SERVICE BULLETIN NO. 136

DATE: February 20, 1973
SUBJECT: Elevator Trim Tab Hinge Inspection
SERIALS AFFECTED: AA5-0001 through AA5-0284
TIME OF COMPLIANCE: Within the next 100 hours of operation

FIGURE 1. ELEVATOR TRIM TAB HINGE INSPECTION

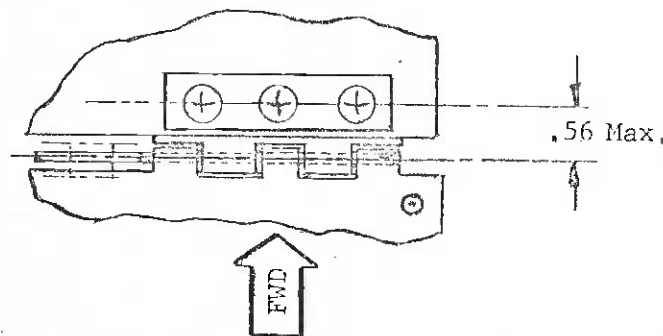
Some aircraft in the above serial number range may have been produced with insufficient hole edge margin in the elevator trim tab outboard forward hinge halves. To prevent possible detachment of the hinge half, the following inspection and modification, if required, must be accomplished within 100 hours of operation.

Measure the distance from the center of the trim tab hinge pin to the center of the three (3) mounting screws in the elevator tip on each elevator. The maximum allowable dimension is .56" (see Figure 1). If the dimension is larger than .56", the forward hinge half must be modified or replaced. If the dimension is less than .56", no further action is required and the aircraft can continue in service.

FIGURE 2. HINGE HALF DOUBLER PLATE ASSEMBLY

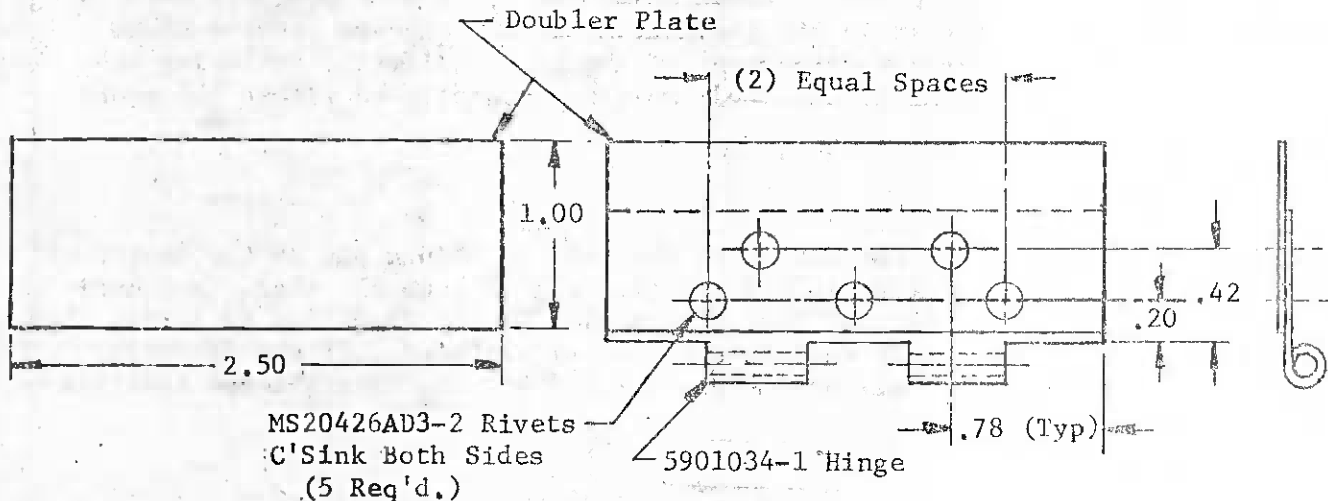
Remove the three (3) hinge half mounting screws in the elevator tip, the cotter pin retaining the hinge pin and remove the hinge pin. Remove the hinge half from the tip. Reinstall hinge pin to support trim tab. Fabricate a doubler of 2024-T3 clad aluminum, .040" thick x 1.00" x 2.50". Assemble the doubler to the hinge half as shown in Figure 2. Match drill mounting holes through tip and doubler. Assemble in reverse order and compensate for the added doubler thickness by eliminating shims as required during reassembly in tip.

- a. Alternate repair method no. 1 is to order a replacement hinge half, part no. 5901034-4 (one for each elevator tip - if required). This hinge half has a longer flange, can be drilled to match the existing tip holes and will directly replace the old hinge half.
- b. Alternate repair method no. 2 is to fabricate a new hinge half (one for each elevator tip - if required), to match the existing hinge half from locally procured MS20257-5 hinge stock material.
